**APTUIT RESPONSE TO
NRC REVIEW OF LICENSE AMENDMENT REQUEST REGARDING
DECOMMISSIONING PLAN AND REQUEST FOR ADDITIONAL
INFORMATION – APTIUIT, LLC (MAIL CONTROL NO. 579062)
February 20, 2013**

FIGURE 1
HISTORIC USE AREAS
B2-119, B2-120, AND B2-122

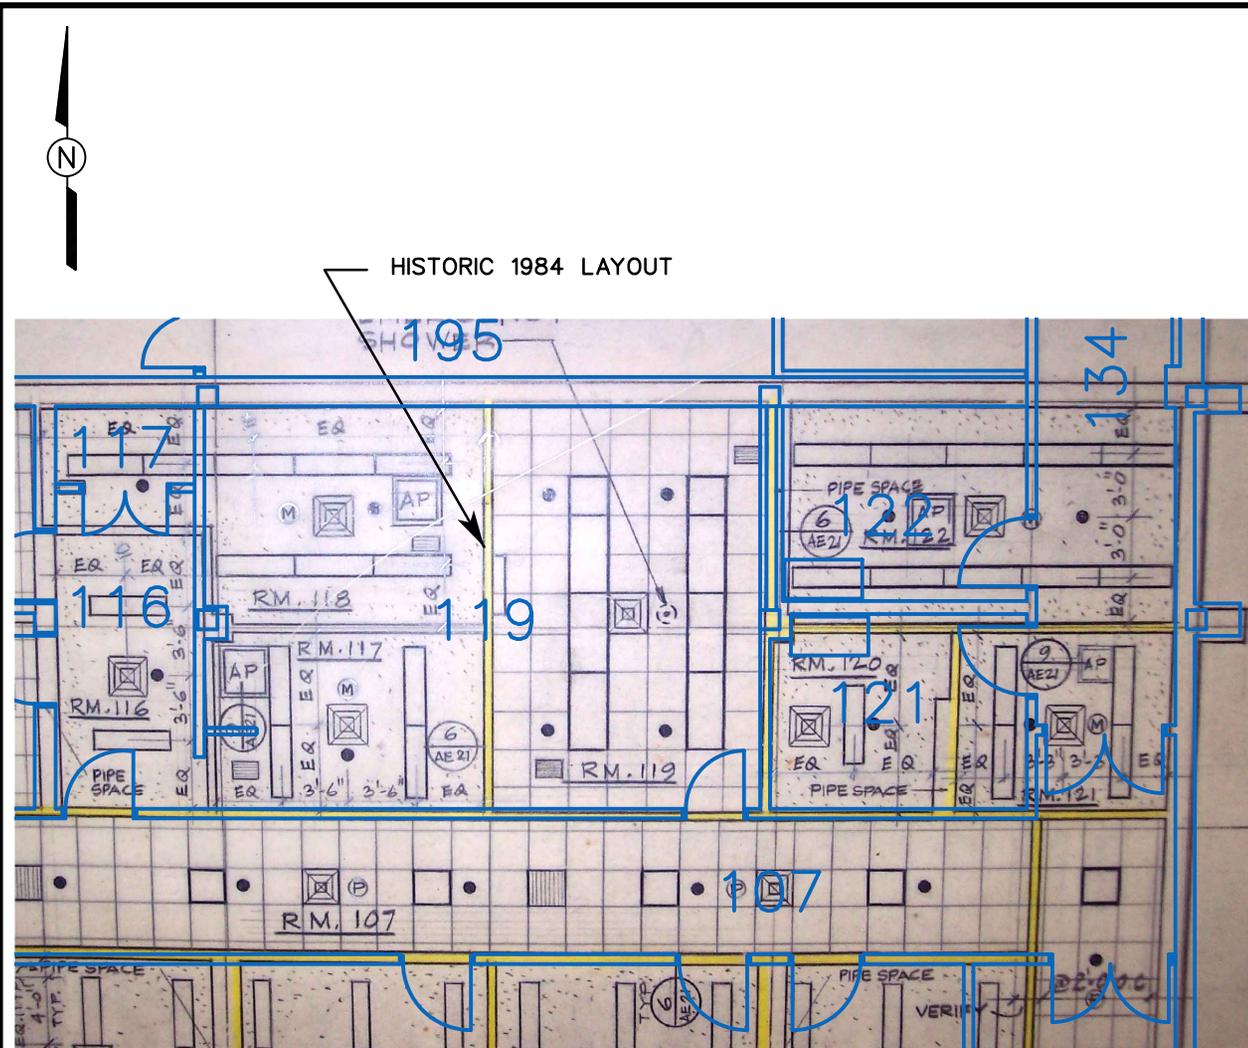
RAI-003: The licensee is requested to provide additional information associated with the physical location of the “3 room suite” as described in the comments section for the line item of Amendment No. 8 of Table 1-1.

The “3 room suite” consisting of Rooms 119, 120, and 122 was mentioned in the application for Amendment No. 8. Aptuit has determined that these rooms were in the B Building. This area has been renovated as shown in the attached figure (Attachment 1, Figure 1) with an overlay of the existing area. Room 119 mentioned in the Amendment No. 8 application is included as part of the current B2-119 decommissioning. Rooms 120 and 122 have been renovated into the current rooms

B2-121 and B2-122 and hallway B2-134. Scoping surveys have been performed in B2-121, B2-122, and B2-134 to confirm that these areas are not impacted. Scoping surveys consisted of scanning and biased direct measurements and wipes. Results of scoping surveys verify that these areas are not impacted. All results were below Aptuit's acceptable surface contamination levels of 5,000 dpm/100 cm² total activity and 1,000 dpm/100 cm² removable activity. Figure 2-7 and Appendix D of the DP, Historical Use Areas, has been revised to address these rooms.
